## **LEGACY SUBDIVISION, PHASE FOUR**

APPLICATION NUMBER 19 DATE August 2, 2012  
APPLICANT Legacy Subdivision, Phase Four  
REQUEST Subdivision

# DETAIL SITE PLAN

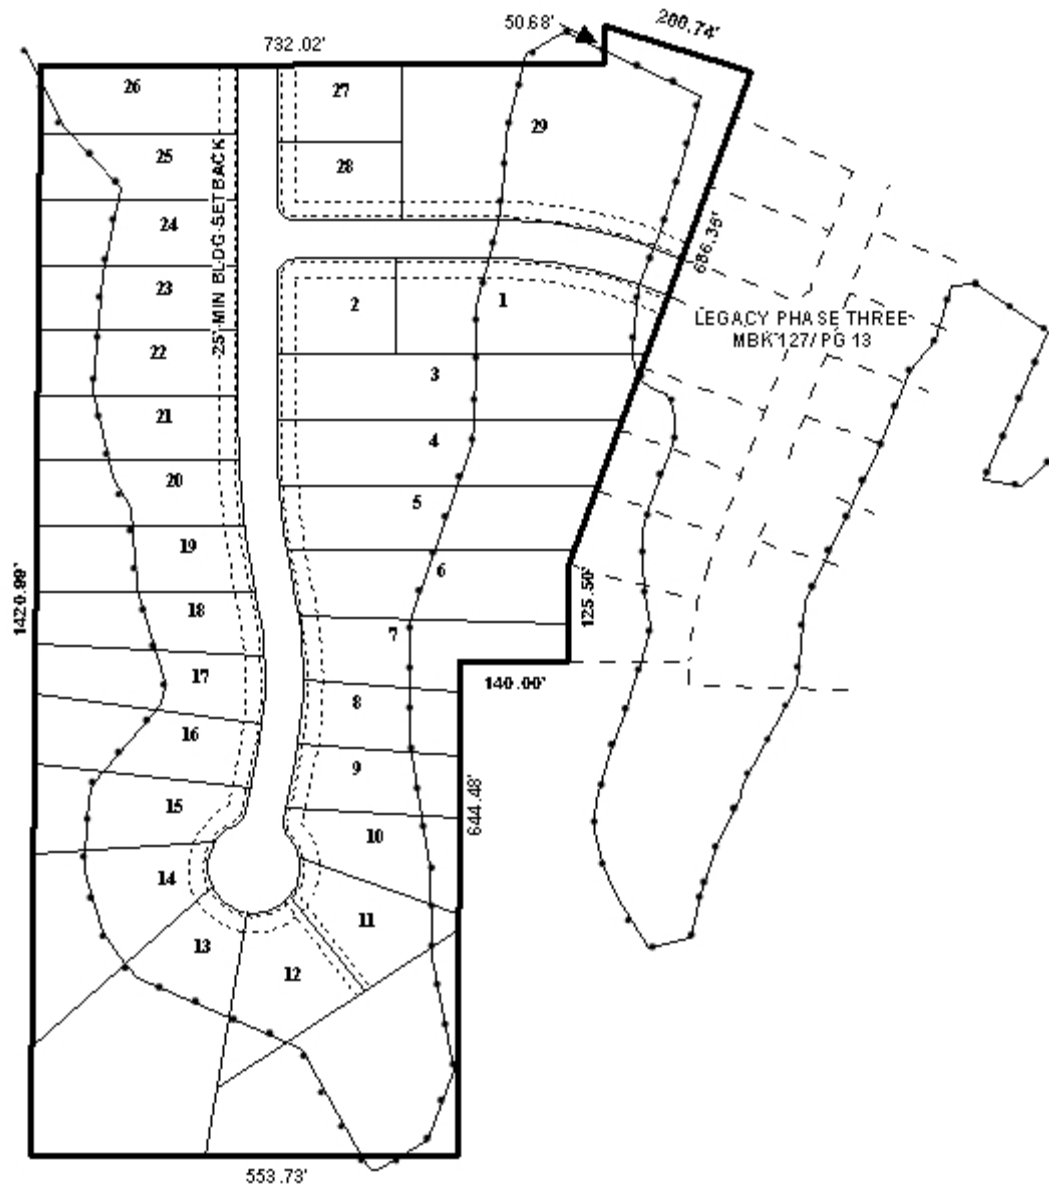
It appears that lot sizes for the proposed phase four meet all minimum requirements for properties with public water and sewer, however, the lot sizes in square feet or acres are not indicated on the plat. Each lot should, however, be limited to one curb-cut each, with the size, design and location of the curb-cut to be approved by Mobile County Engineering, and to comply with AASHTO standards.

The preliminary plat includes a note stating that each lot shall have a 40-foot minimum building setback along all streets, however, the setback line indicated on the plat only shows a 25-foot setback. The plat should be revised to consistently depict, label and note the desired minimum building setback, which in no case shall be less than 25-feet. It should also be noted that a 40-foot setback for proposed lots 2 and 28 may cause siting difficulties for new buildings, due to the decrease in available buildable area.

A detention facility is proposed for the site, however, there are no notes regarding its maintenance as a common area. Notes should be placed on the plat stating that maintenance shall be the responsibility of the property owners.

As previously mentioned, the lot size information is not depicted on the preliminary plat. All lots should be labeled with their size in square feet and acres, or a table should be placed on the plat with the same information.
